**CENTRAL ARKANSAS WATER
JACK H WILSON WATER TREATMENT PLANT
WILSON RENEWAL AND RESILIENCY PROJECT
ADDENDUM NO. 5
JANUARY 30, 2025**

This Addendum forms part of the Contract Documents and modifies the Specifications and Drawings as noted below. Acknowledge receipt of the Addendum in the space provided on the Bid Proposal. Failure to acknowledge receipt of the Addendum may subject the Bidder to disqualification.

BOTTOM PLAN - NEW
3/8" = 1'-0"

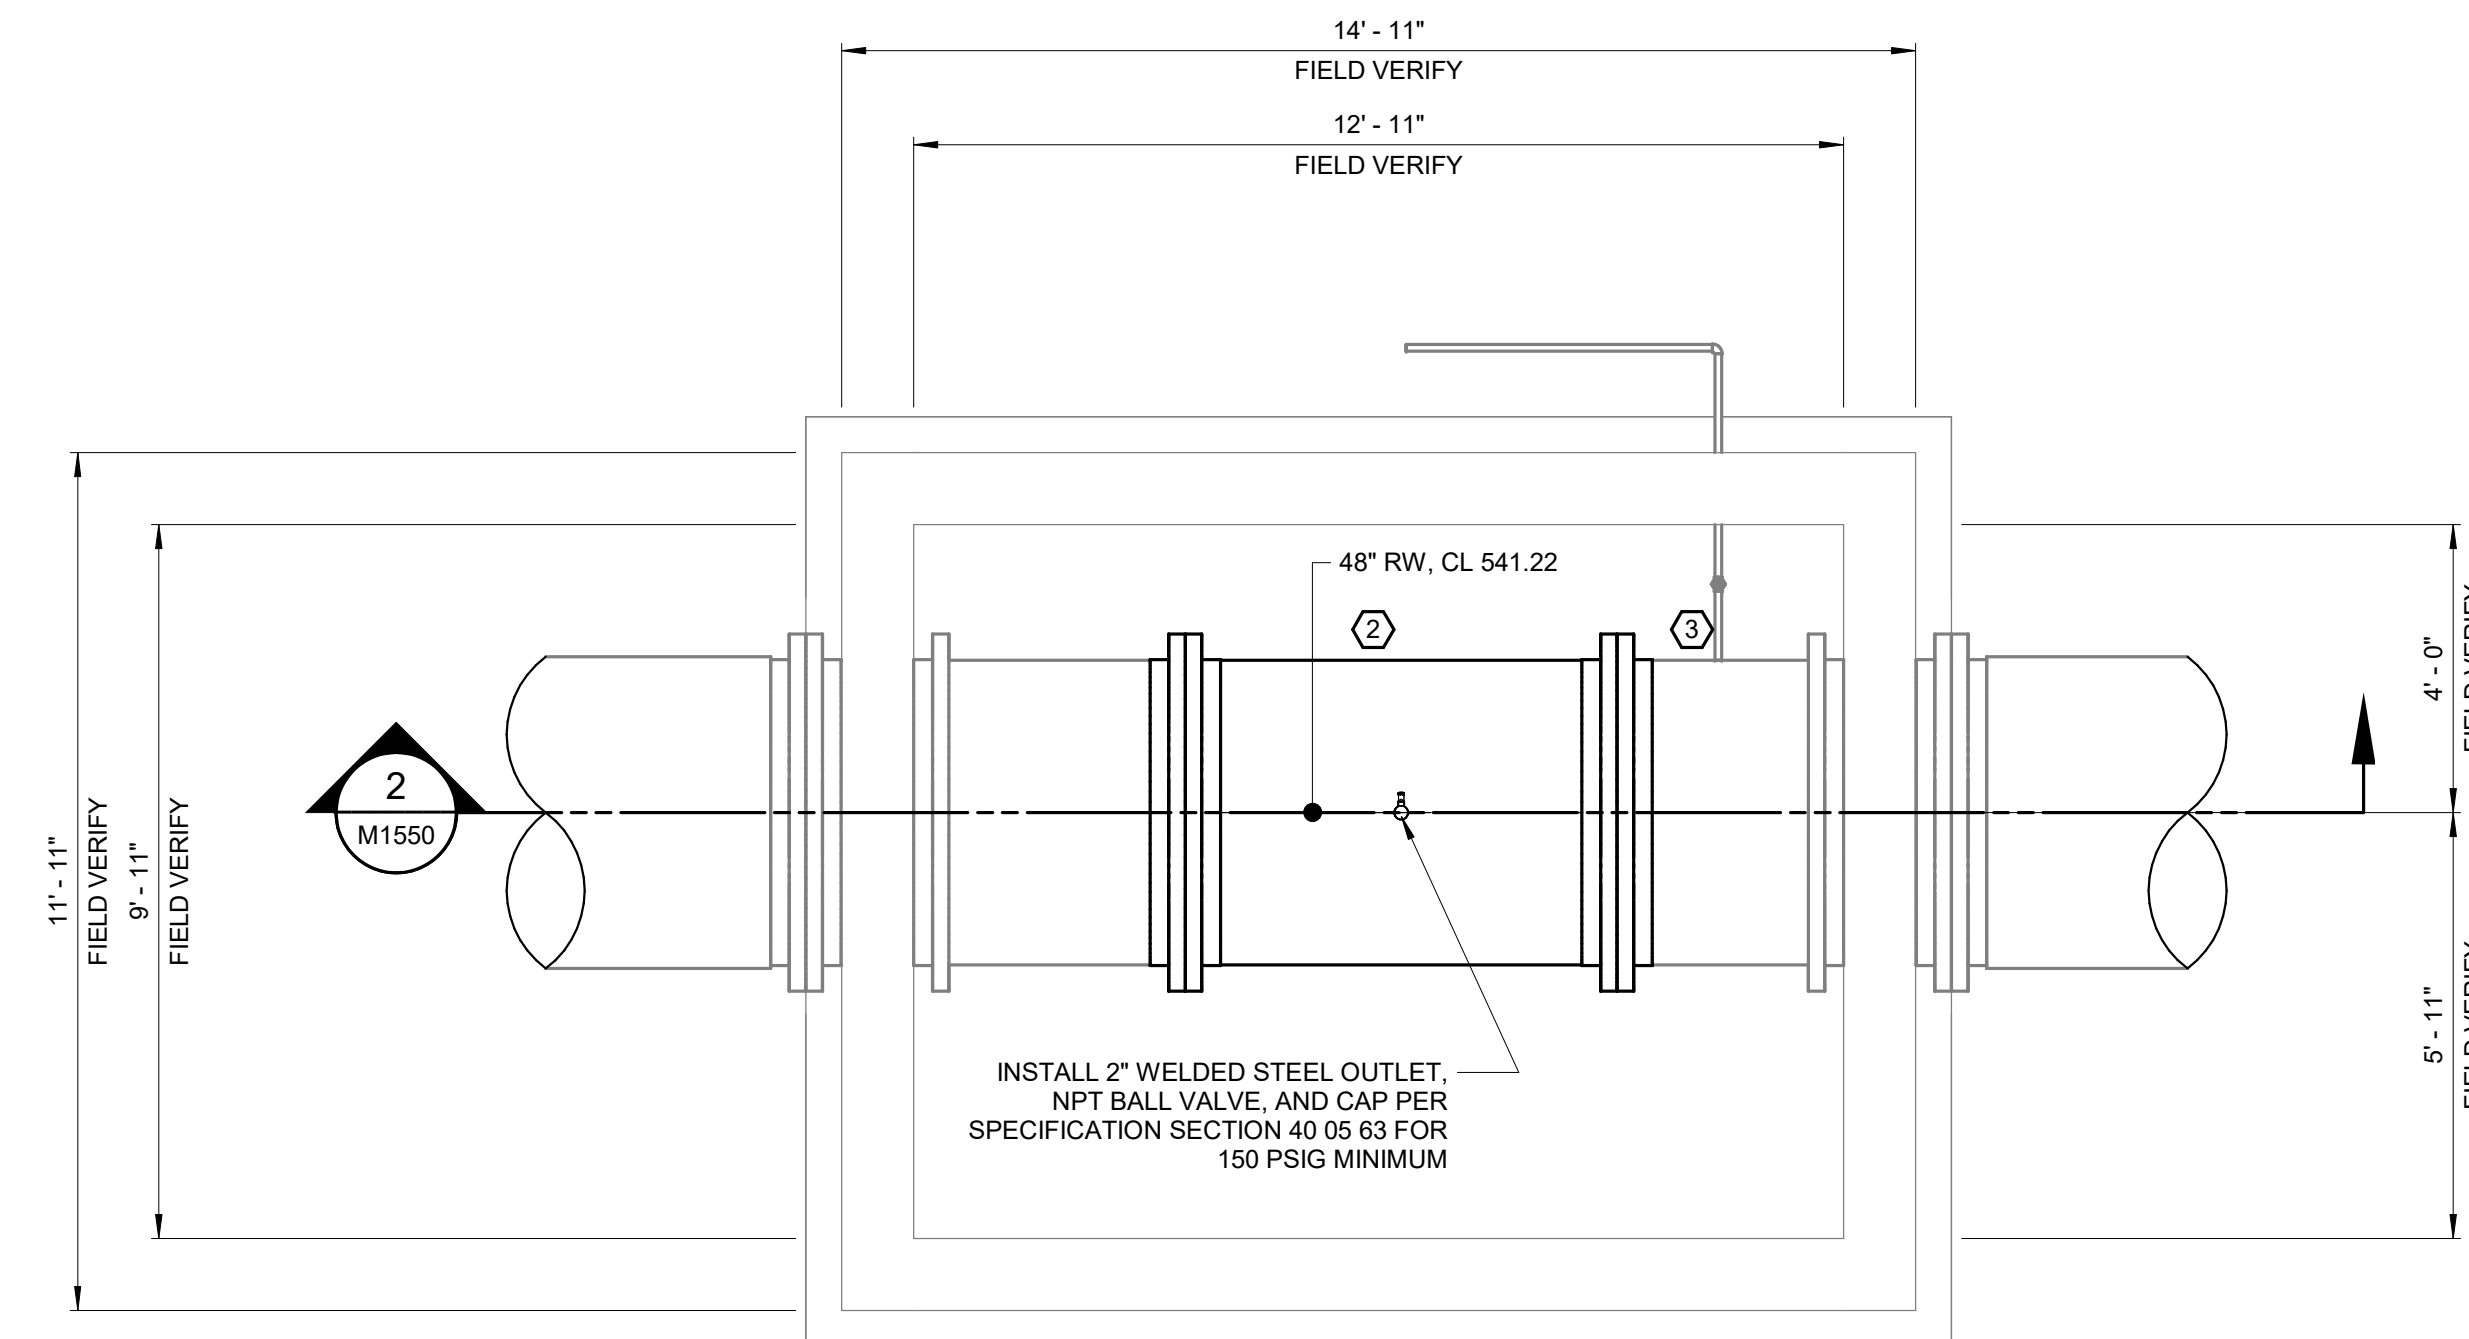
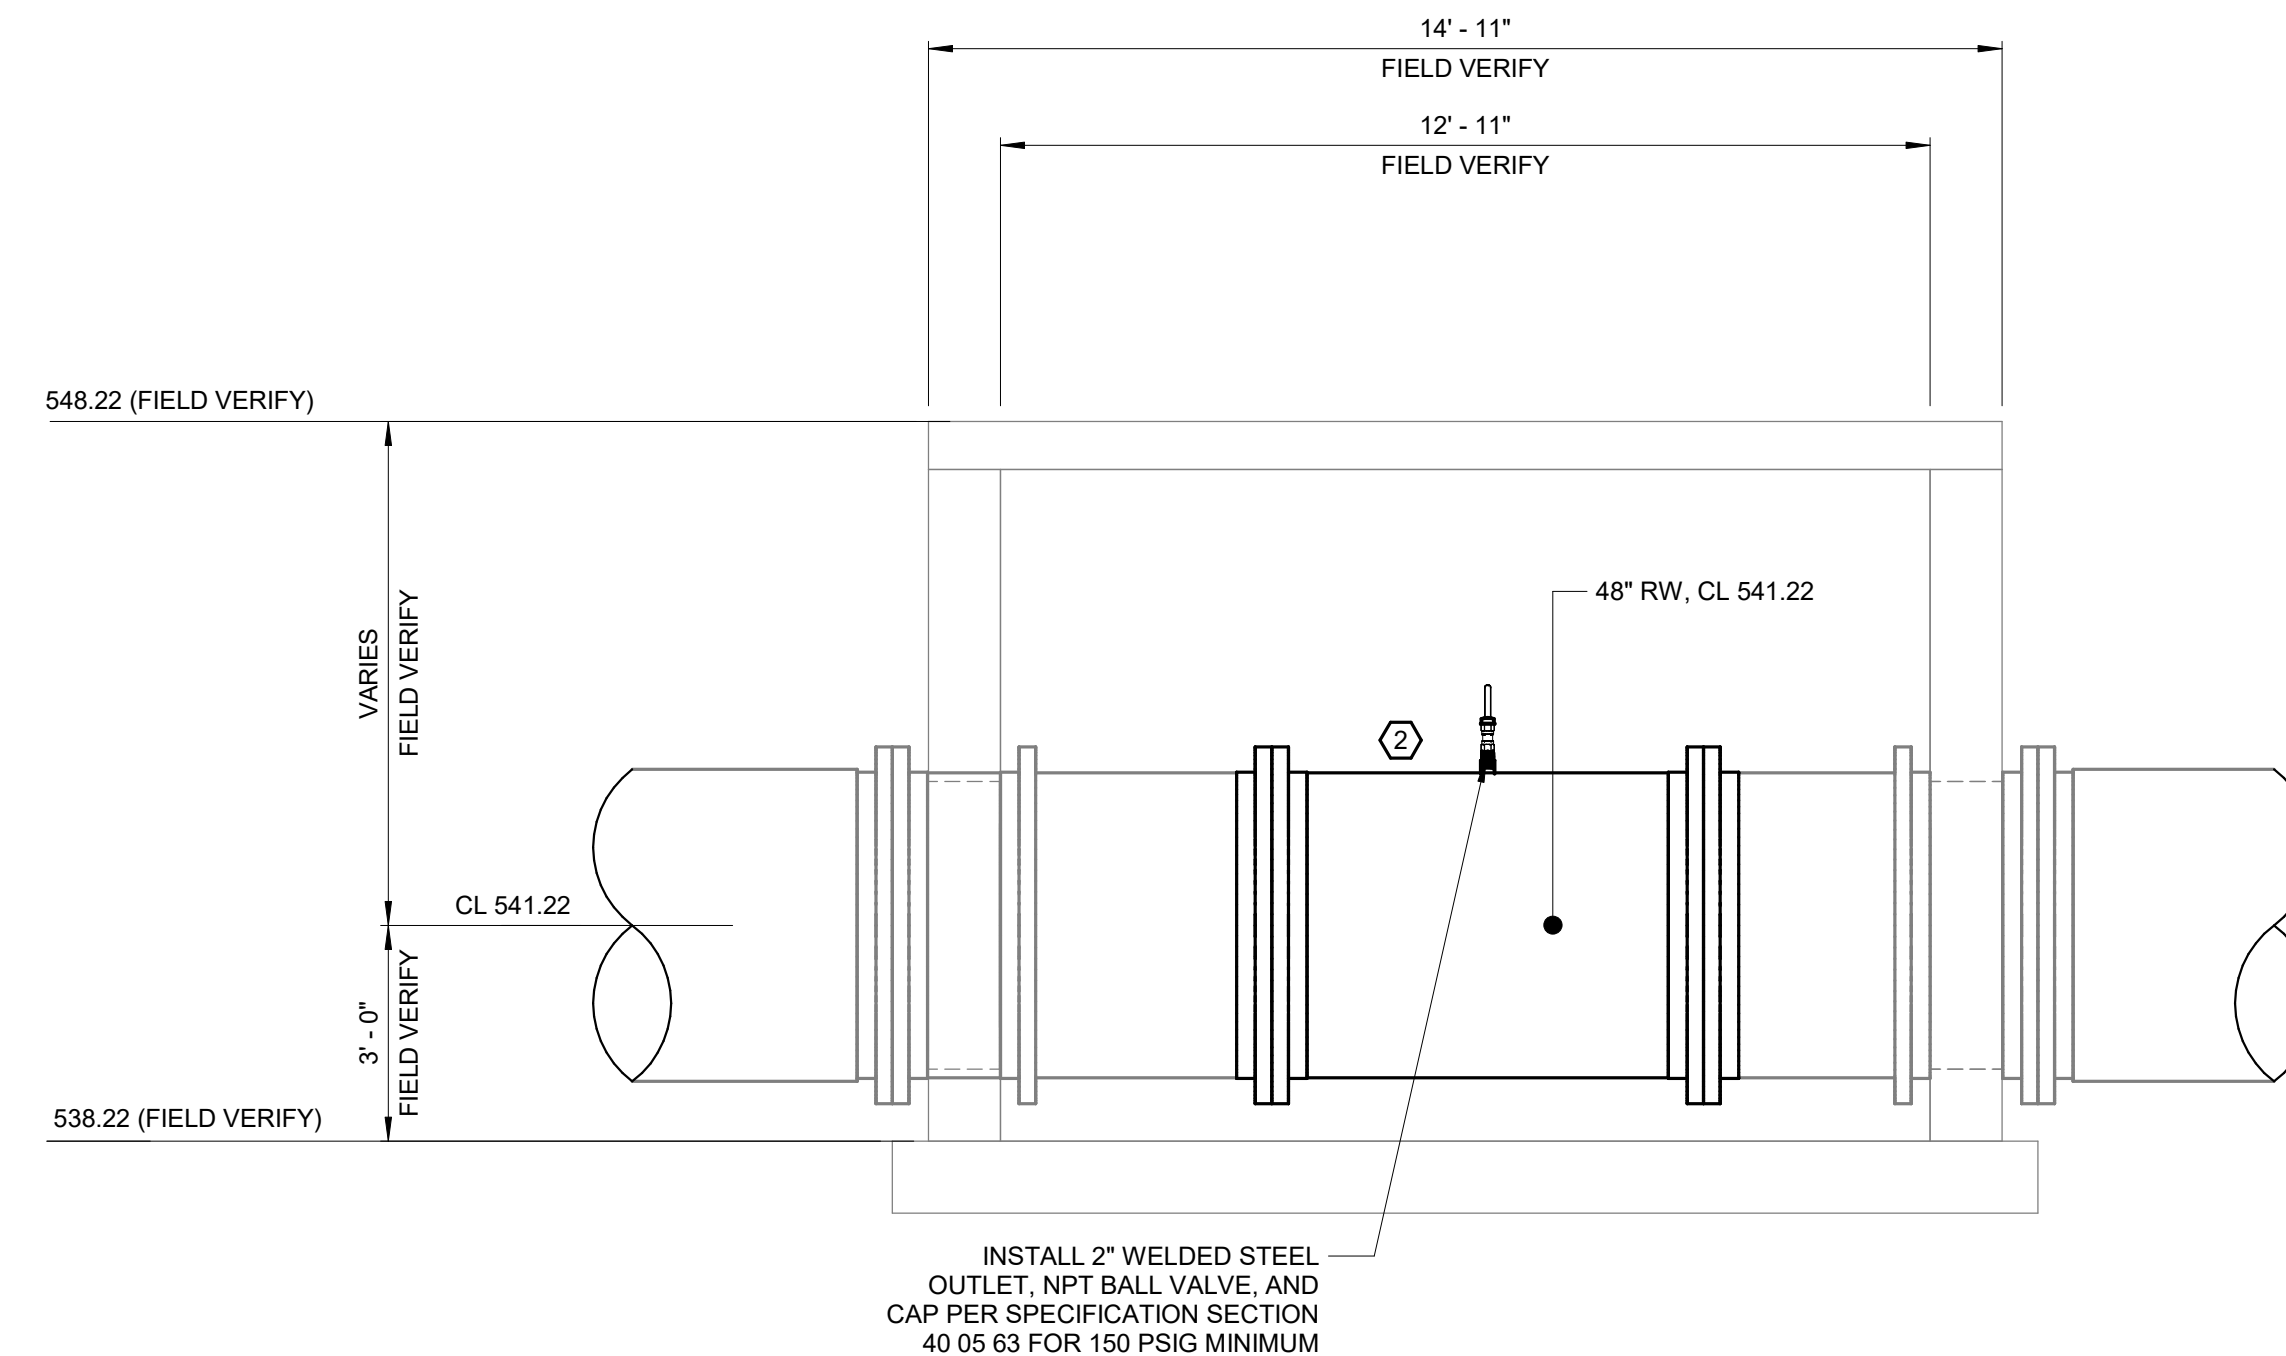
1. Drawing M1550 EXISTING RAW WATER METER VAULT – MECHANICAL – BOTTOM PLAN AND SECTION – DEMO & NEW
 - a. Add the attached new drawing sheet M1550 EXISTING RAW WATER METER VAULT – MECHANICAL – BOTTOM PLAN AND SECTION – DEMO & NEW.
2. Drawing M8001 ADMINISTRATION BUILDING – MECHANICAL – FIRST FLOOR AND CRAWL SPACE PLAN

- ① 48" DIP FL X MJ SPOOL. PERFORM SURFACE PREPERATION AND COATING OF THE EXISTING SPOOL PER SPECIFICATION 09 90 00. PROVIDE NEW MJ AND FLANGE GASKETS PER SPECIFICATION 33 11 13.
- ② REPLACE VENTURI FLOW METER WITH 48" DIP FL X FL SPOOL. LENGTH SHOWN IS APPROXIMATE. FIELD MEASURE TO VERIFY.
- ③ SAMPLE LINE CONNECTION TO REMAIN.
- ④ DEMO EXISTING FLOW METER INSTRUMENTATION. SALVAGE FLOW ELEMENT TO OWNER. TERMINATE ELECTRICAL AT EXISTING JUNCTION BOX.

DATE:	NOVEMBER 2024
HAZEN NO.:	60711-003
CONTRACT NO.:	1
DRAWING NUMBER:	M8001

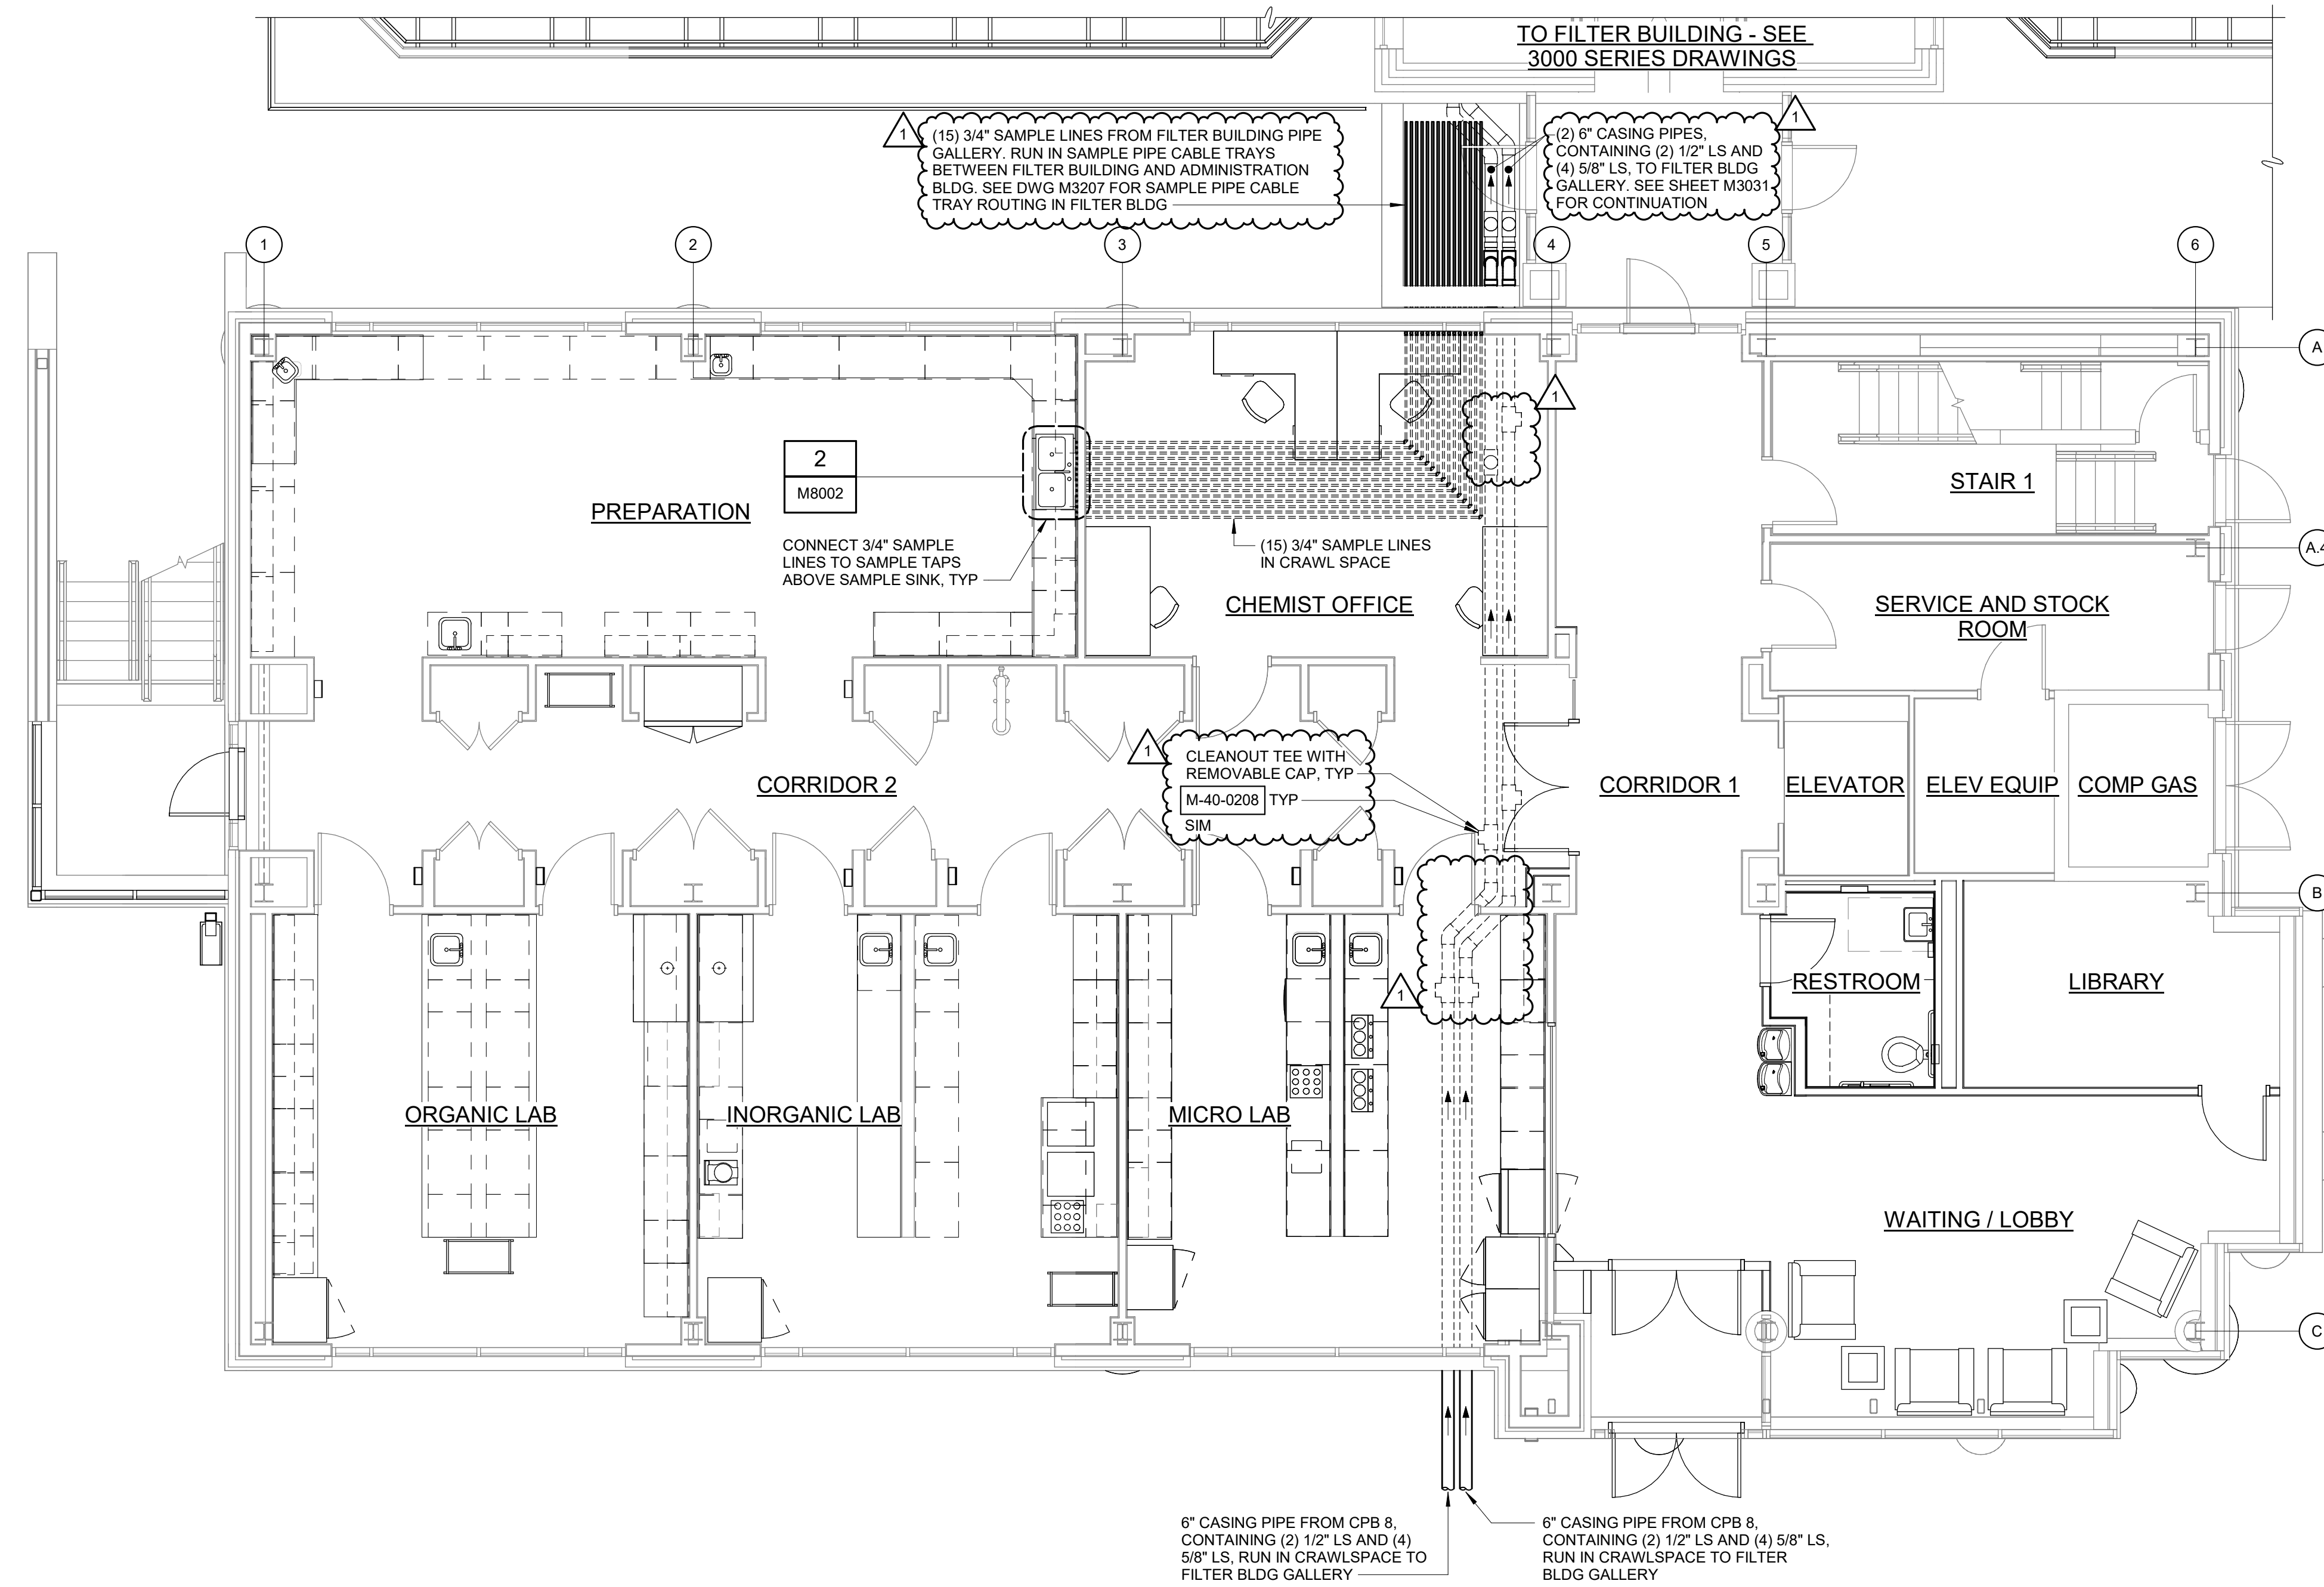
NOTES:
 1. ALL SAMPLE PIPING RUN FROM GALLERY TO LAB SAMPLE SINK SHALL BE PEX PIPING.
